car stereo Service Bulletin No.84

Model: CDX-5, CDX-R7

Subject: No Loading, No Eject

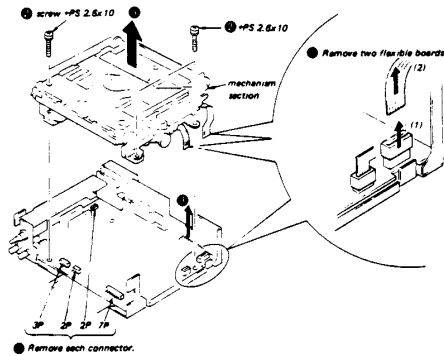
The disk cannot be loaded or ejected. The E ring disjoins due to a worn out down-gear shaft.

Replace the loading gear assembly as described below:

Description	Part Number
Loading Gear Assembly	X-3320-540-1

Friction lever ass'y Roller gear Polywasher 1.2 (one extra) Stopper E 1.2 (one extra)

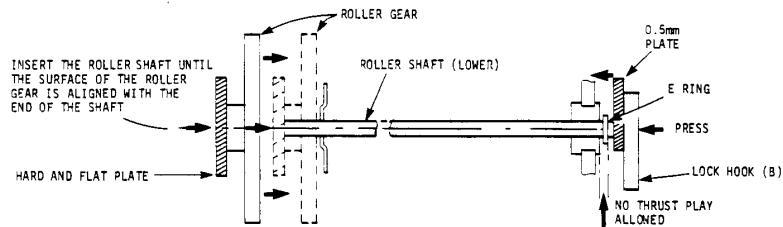
a. Before pressing the roller gear toward the lower roller shaft, insert a plate of about 0.5mm thick between the shaft and lock hood (B).

b. Place a hard and flat plate on the roller gear. While applying force to lock hook (B) press and fit the gear to the lower roller shaft until the end of the shaft is level with the surface of the roller gear.

Insert the roller shaft until the surface of the roller gear is aligned with the end of the shaft.
